Oil and Gas NSPS and NESHAP

American Petroleum Institute
Presentation to:
Office of Management and Budget
March 22, 2012

Reduced Emissions Completions Cost Effectiveness (\$/ton)²

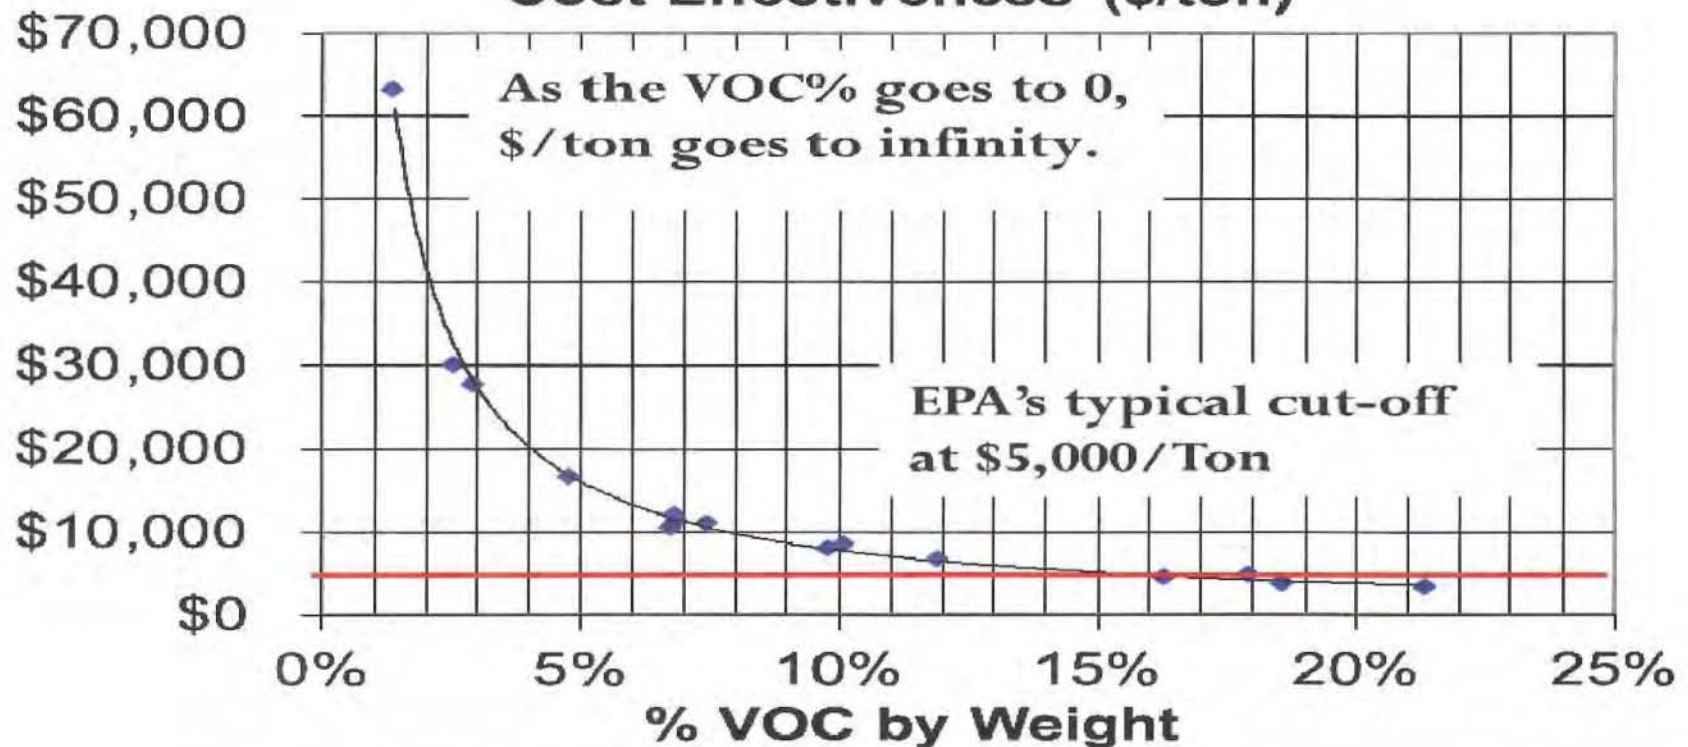
- EPA proposed requirements to reduce VOCs from completions of gas wells following hydraulic fracturing with **no VOC content threshold for applicability.**²
- EPA should establish a VOC threshold of **10% VOC content by weight** for all sources in the rule to assure the NSPS is cost effective per the Clean Air Act¹

Impacts of REC Requirements on US Unconventional Drilling³

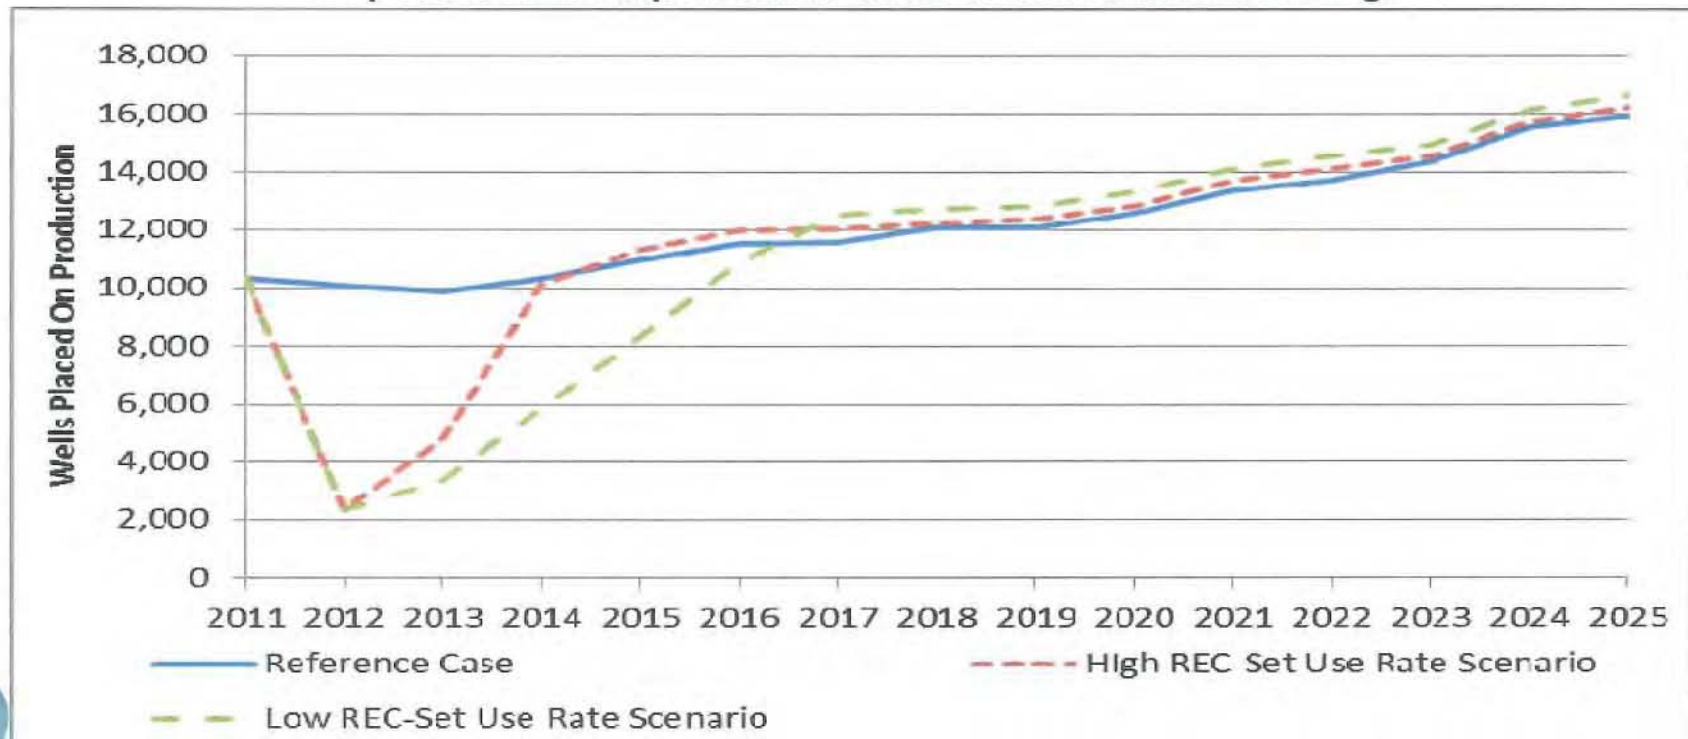
Impacts of First 4 Years (2012-2015) of RECs on US Unconventional Natural Gas Wells without Phase-in Period³

- **Drilling reduced by 31% to 52%** or reduction of 12,700 to 21,400 wells.
- **5.8 to 7.0 quadrillion Btu (Quads)** of natural gas would not be developed and produced by 2015, a 9% to 11% reduction.
- **1.0 to 1.8 billion barrels of liquids** would not be developed and produced by 2015, a 21% to 37% reduction.
- **Total royalties of \$7.0 to \$8.5 billion** would not be paid.
- **State revenues from severance taxes amounting to \$1.9 to \$2.3 billion** would be delayed.

Storage Vessel Control Cost Effectiveness (\$/ton VOC)¹⁰

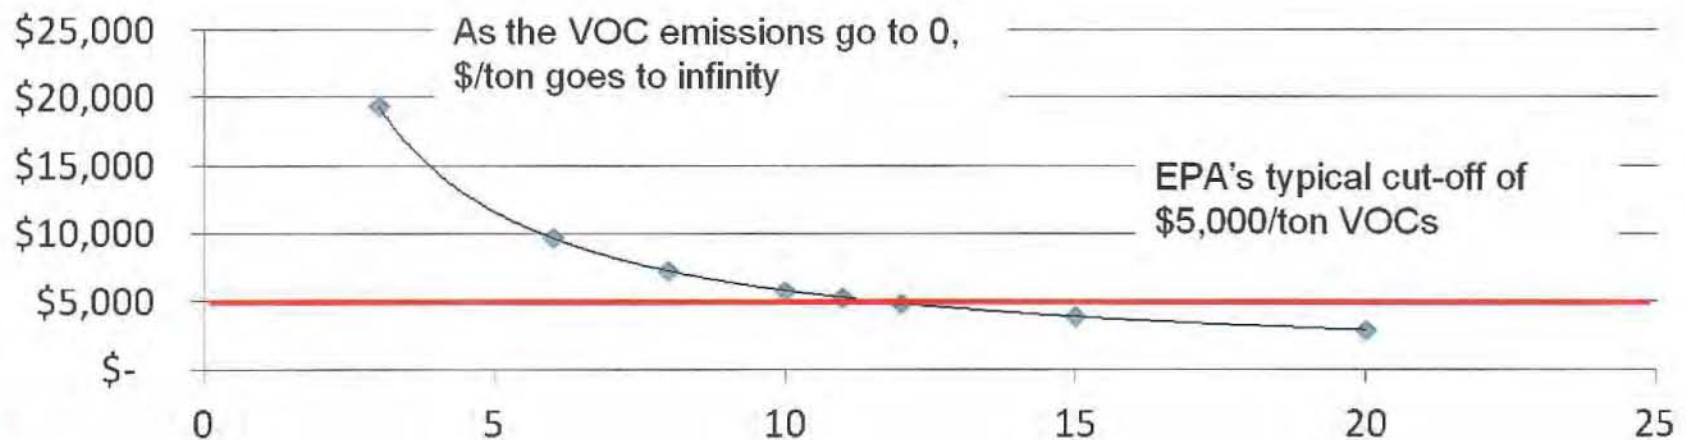
- Applicability to storage vessels should be limited to:
 - Emissions ≥ 12 TPY VOC.
 - Permanent installations (i.e., ≤ 180 days is temporary)
- EPA should **allow 90 days** after the first date of production to:
 - Determine the production rate, composition, and pressure,
 - Calculate the emissions, and
 - Install the controls
- EPA should allow for **controls to be removed** once emission **decline below 8 TPY VOC** due to production decline.
